SUBJECT: ISSUANCE OF AMENDMENT NO. 7 TO FACILITY OPERATING LICENSE
NO. NPF-63 - SHEARON HARRIS NUCLEAR POWER PLANT, UNIT 1,
REGARDING TECHNICAL SPECIFICATIONS RELATING TO CYCLE 2
OPERATION (TAC NO. 67089)

Amendment No. 7
License No. NPF-63

SAFETY EVALUATION BY THE OFFICE OF NUCLEAR REACTOR REGULATION
SUPPORTING AMENDMENT NO. 7 TO FACILITY OPERATING LICENSE NO. NPF-63
CAROLINA POWER & LIGHT COMPANY, et al.
SHEARON HARRIS NUCLEAR POWER PLANT, UNIT 1
DOCKET NO. 50-400

**FIGURE 2.1-1
REACTOR CORE SAFETY LIMITS - THREE LOOPS IN OPERATION**

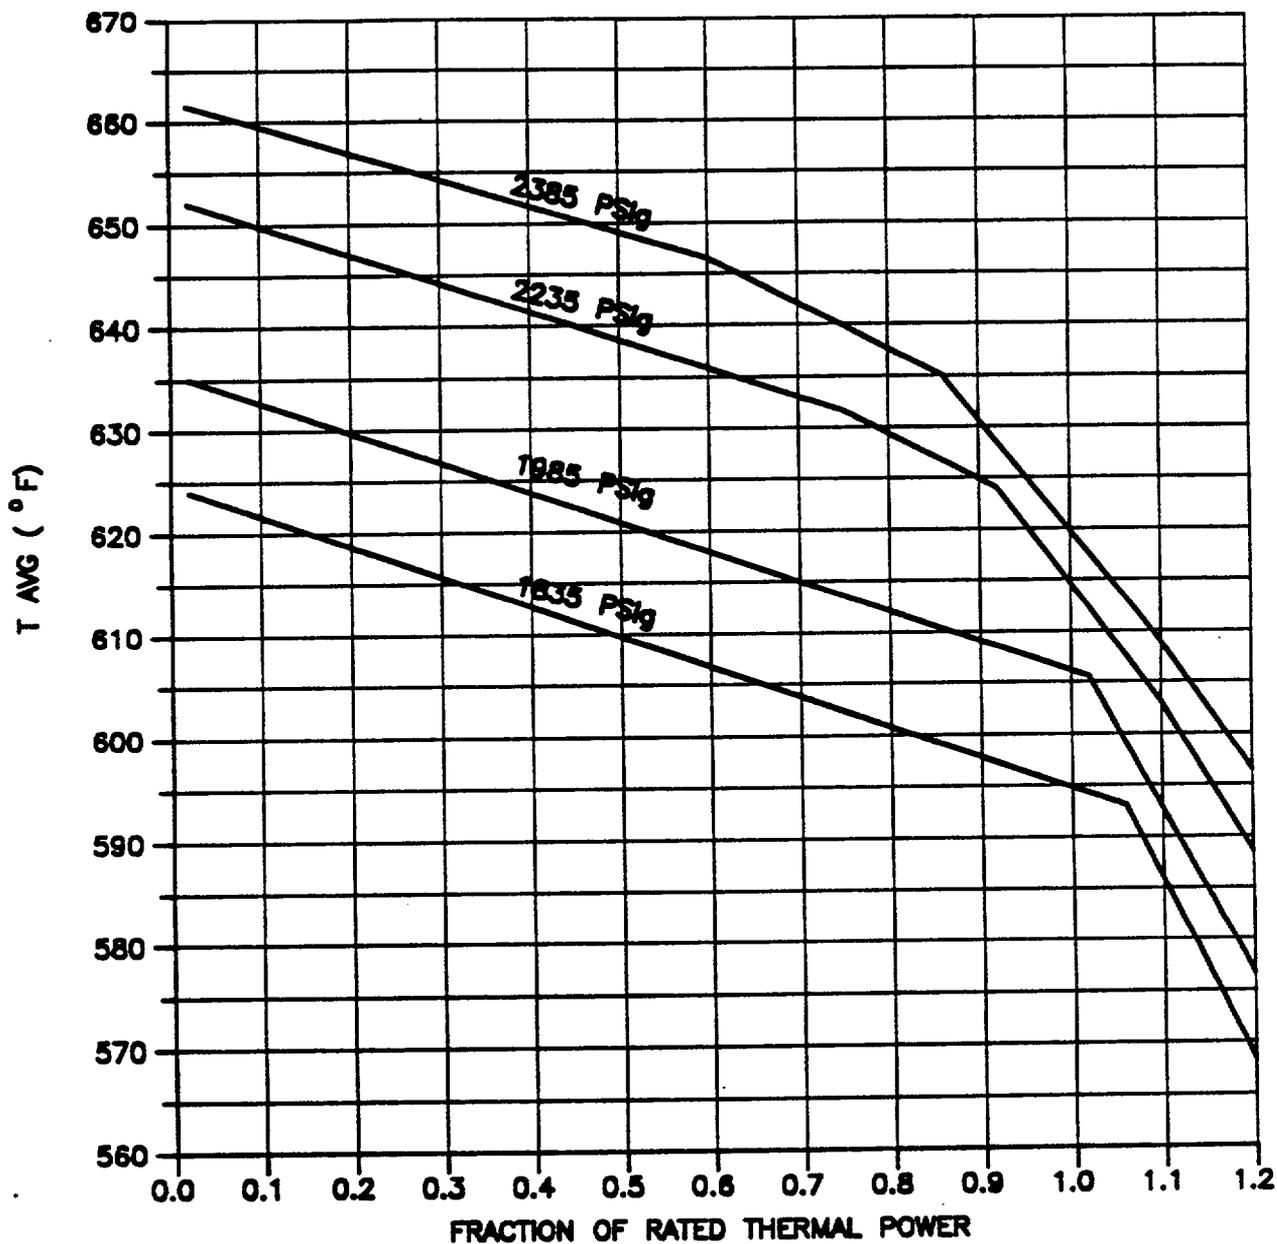
i.e., the existing multiplier has been increased to 0.3. This change allows higher values for $F_{\Delta H}$ at reduced power level. The licensee's motivation for this change is for greater operational

flexibility at reduced power levels. The criterion for the acceptability of this change is the value of the minimum DNBR to be no less than >1.30 . The core limit curves in TS Fig. 2.1-1 represent thermal power, RCS pressure and average temperature for core states for which minimum departure from nucleate boiling ratio (MDNBR) >1.30 . The full power value of $F_{\Delta H}$ remains the same. Therefore, the LOCA analyses presented in the FSAR, which assume 100% power operation, are not affected. The proposed change does affect event analyses at a fractional power level and events which rely on $OT\Delta T/OP\Delta T$ trip function for protection. The existing setpoints were compared to the revised core limits with the $0.3 F_{\Delta H}$ multiplier, and it was determined that the existing setpoints envelope the new limits. Therefore, the non-LOCA events analyses presented in the FSAR are still valid.

- (a) TS 3.2.3.6, the equation used to determine $F_{\Delta H}$; and
- (b) TS Figure 2.1-1, core limit curves.

The discussion in Section 2.3.1 indicates that the proposed change is enveloped by the existing LOCA and non-LOCA analyses in the FSAR and, therefore, are acceptable.

FIGURE 3.1-1
SHUTDOWN MARGIN VERSUS RCS BORON CONCENTRATION
MODES 3, 4, AND 5

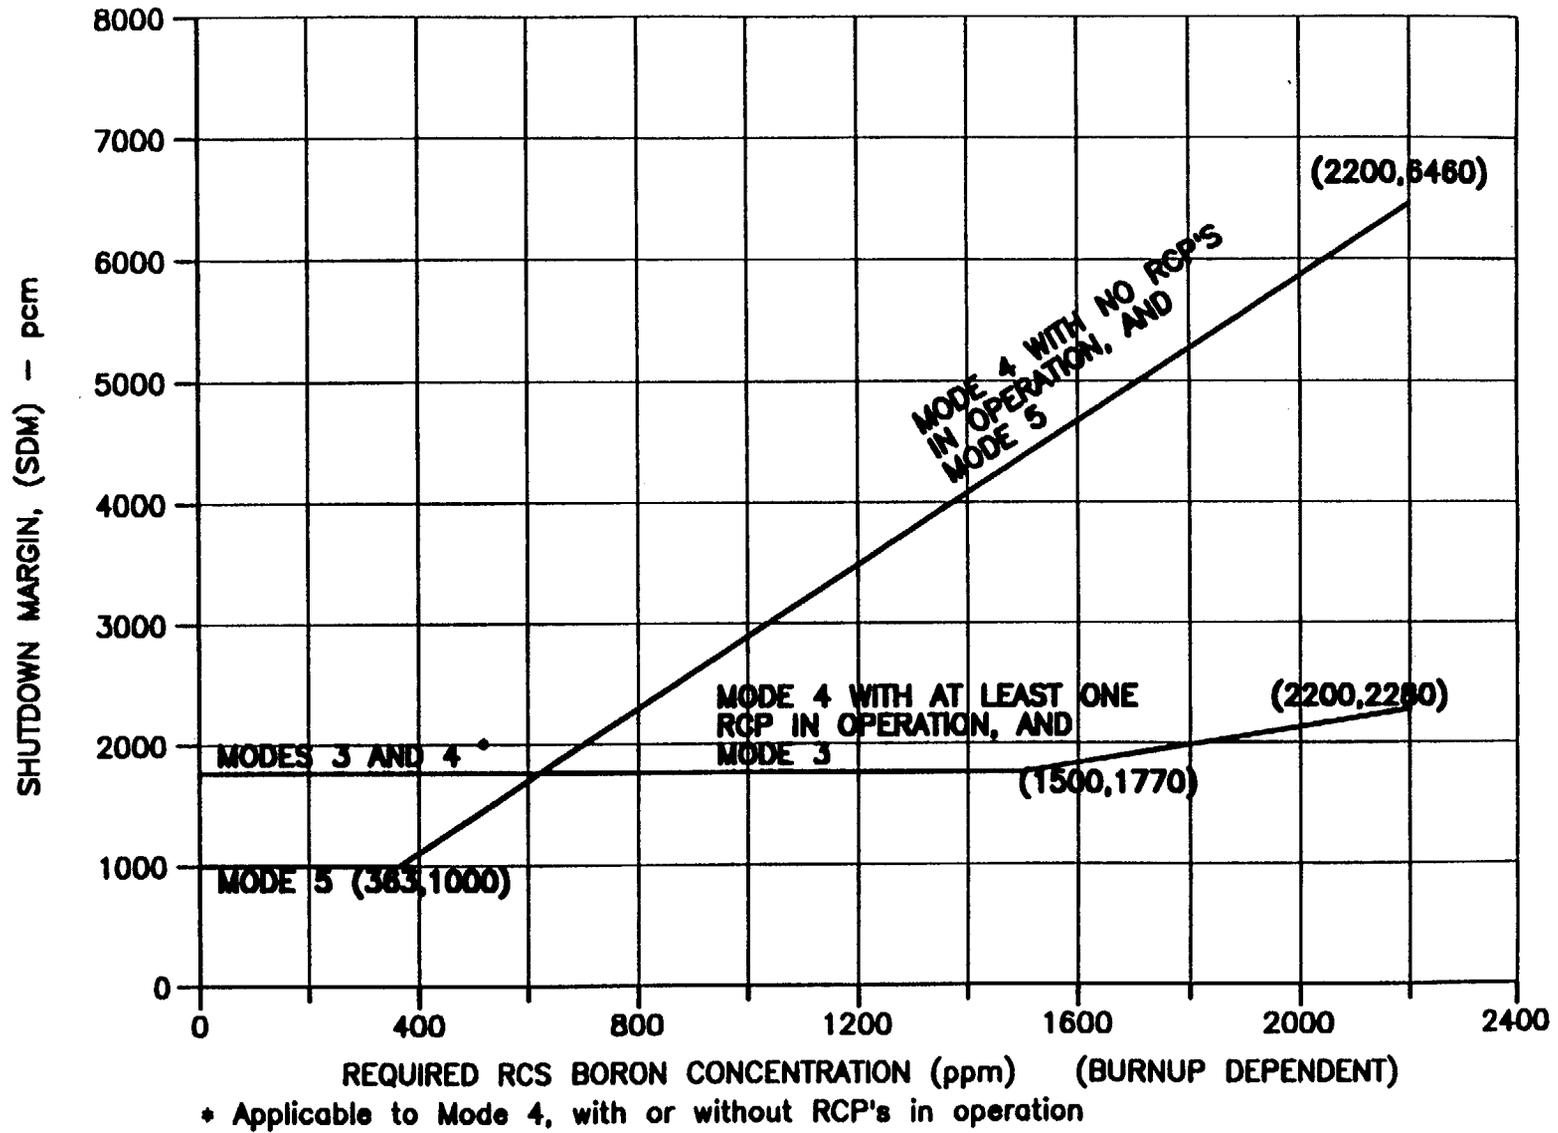
The proposed amendment modifies TS 3/4.1., Shutdown Margin, from a fixed to a variable shutdown margin requirement. Due to increased enrichment and low leakage loading configuration, Shearon Harris will have higher shutdown margin requirements at the beginning of Cycle 2 (BOC-2) than the corresponding value at BOC-1 (Ref. 2).

coolant system cooldown. The variable part arises from the requirements of an inadvertent boron dilution event, where the shutdown margin is varied as a function of primary boron concentration, to guarantee a minimum of 15 minutes for operator action prior to loss of shutdown margin. The existing TS require the shutdown margin to be fixed at the higher BOC value throughout the cycle, even though the required shutdown margin decreases with core burnup. The proposed change alleviates this condition by introducing a variable shutdown margin for operating modes 3, 4 and 5 to take credit for reduced shutdown margin toward the end of cycle. Rod insertion limits (in TS 3.1.3.6) ensure adequate negative reactivity to take the reactor subcritical from modes 1 and 2. Therefore, the variable shutdown margin is not applicable in these modes.

The proposed reduction in shutdown margin impacts only the inadvertent boron dilution, which has been reanalyzed. It was determined that the proposed sliding shutdown margins maintain at least 15 minutes from alarm indication to loss of shutdown margin, as required by section 15.4.6 of the Standard Review Plan. The shutdown margin requirements for modes 1, 2, 3 and 4 remain equal to or greater than those in the existing TS, and the main steam line break event is not affected by the revision of the shutdown margin requirements. Therefore, the proposed revisions to TS 3/4.1.1.1 and 3/4.1.1.2 do not involve a reduction in the margin of safety.

**FIGURE 3.1-2
 ROD GROUP INSERTION LIMITS VERSUS THERMAL POWER
 THREE-LOOP OPERATION**

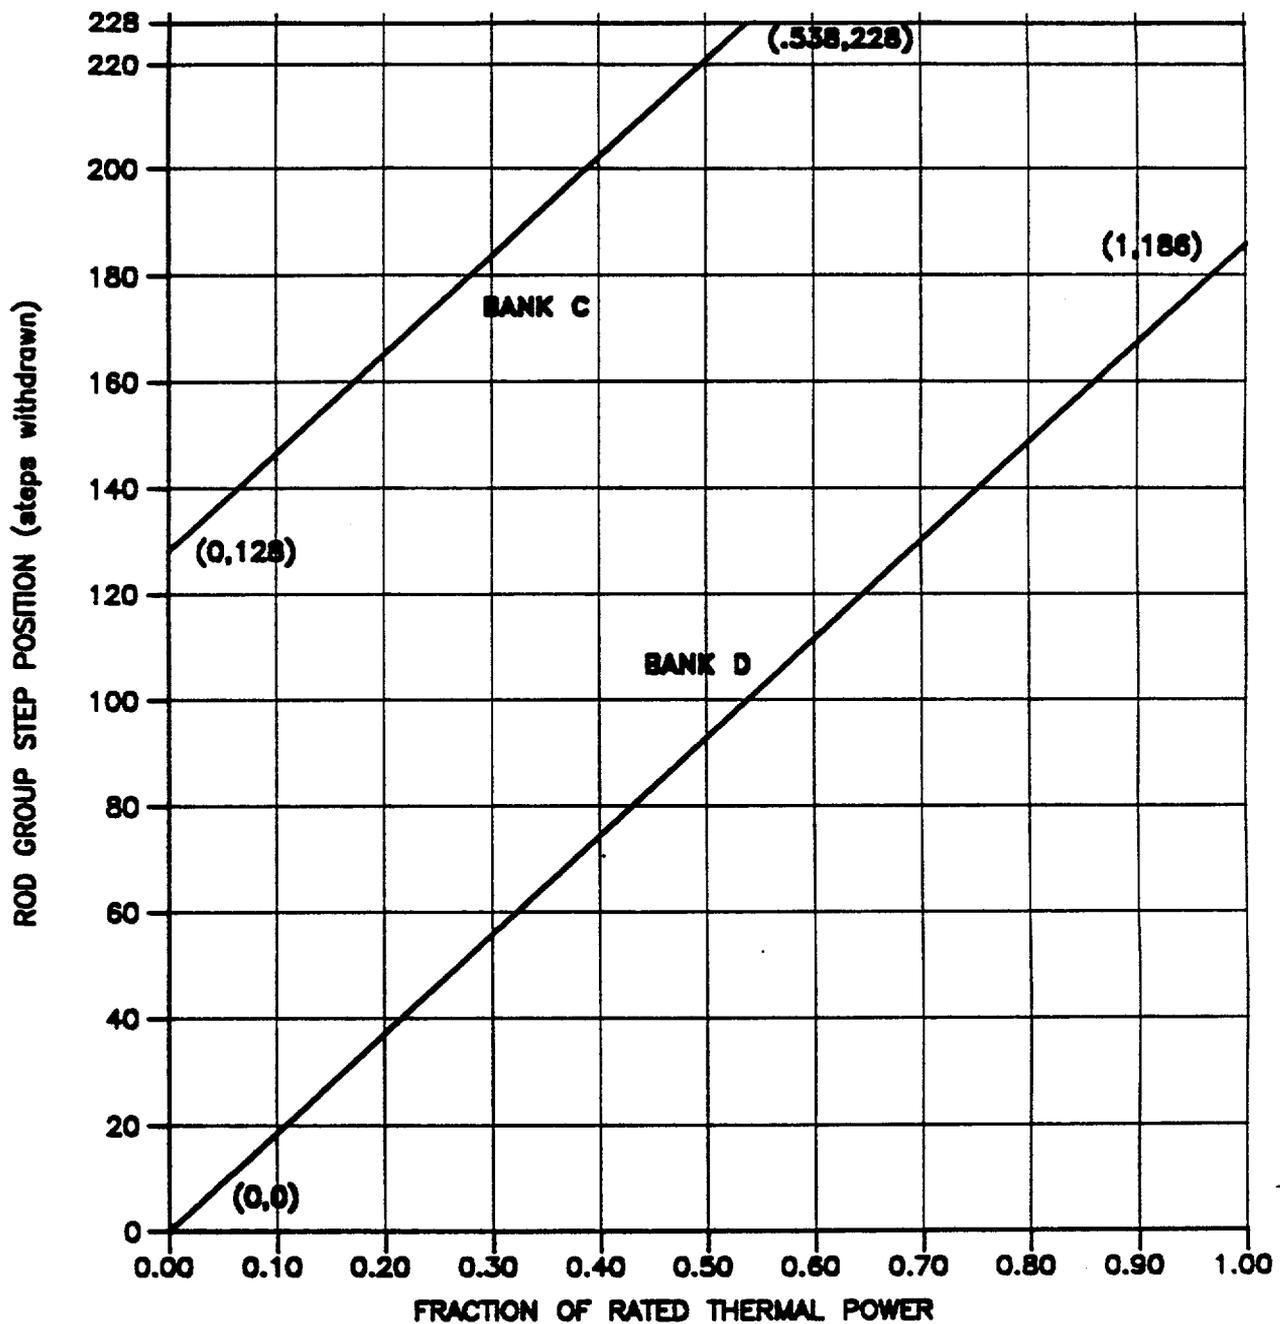
In summary, we find that the proposed control rod Bank-D reconfiguration is necessary for the intended operation of Cycle 2 in Shearon Harris; and the effects of the proposed insertion limits are within the FSAR analyses limits and are acceptable. Therefore, the proposed TS change in Fig. 3.1-1 is acceptable.

FIGURE 3.2-2
 $K(Z)$ - LOCAL AXIAL PENALTY FUNCTION FOR $F_0(Z)$

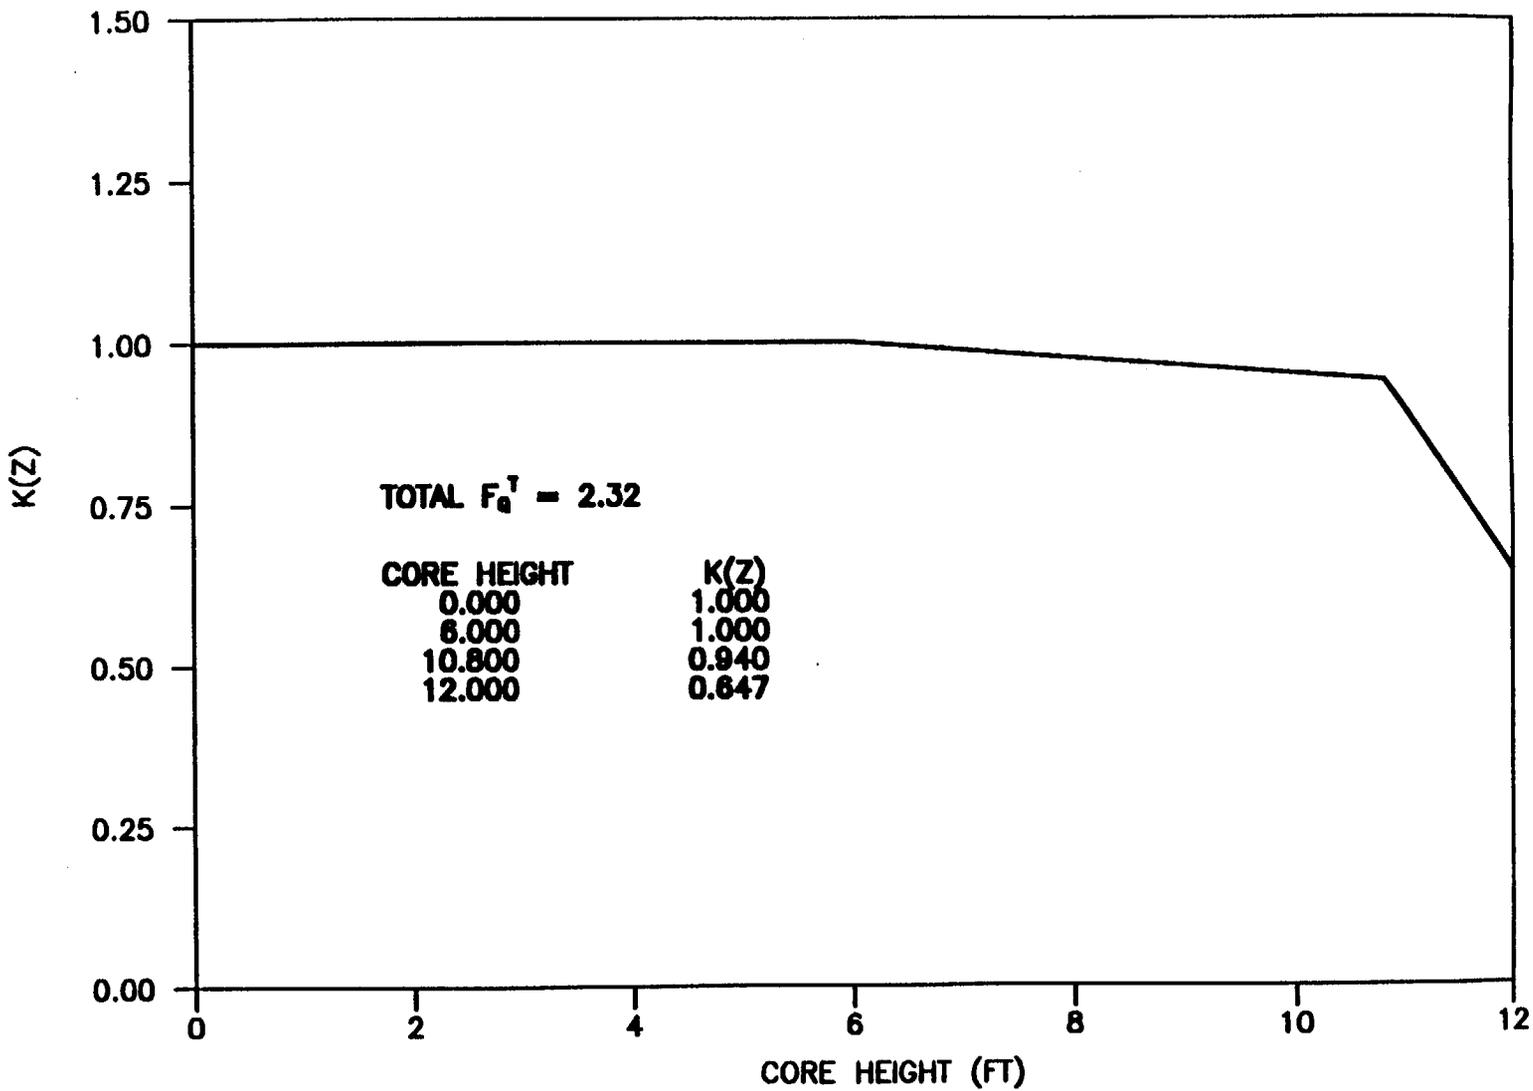
- (a) TS 3.2.2, increasing the heat flux hot channel factor;
- (b) TS Fig.3.2.2, revising the local axial penalty function $K(z)$;
- (c) TS 3/4.2.1, replacing CAOC with RAOC/Base Load operation;
- (d) TS 4.2.2.1 surveillance, replacing F_{xy} with F_Q ;
- (e) TS Table 2.2-1, revising the $f(\Delta I)$ function; and
- (f) TS 6.9.1.6, delineating the contents of the revised peaking factor limit report.

The discussion in Section 2.2.1 indicates that the proposed changes to F_0 and the associated axial function $K(z)$ do not affect the LOCA and non-LOCA analyses of the FSAR. Thus, the consequences of previously evaluated accidents are not increased as a result of these changes. Replacing the CAOC with RAOC/Base Load operation and revising the $f(\Delta I)$ function maintains the validity of the analyses in the FSAR. The replacement of the F_{xy} with F_Q surveillance maintains the intent of the technical specification for a direct measurement of the flux and power distribution. The change in the TS 6.9.1.6 is administrative in nature. Therefore, the proposed changes are acceptable.
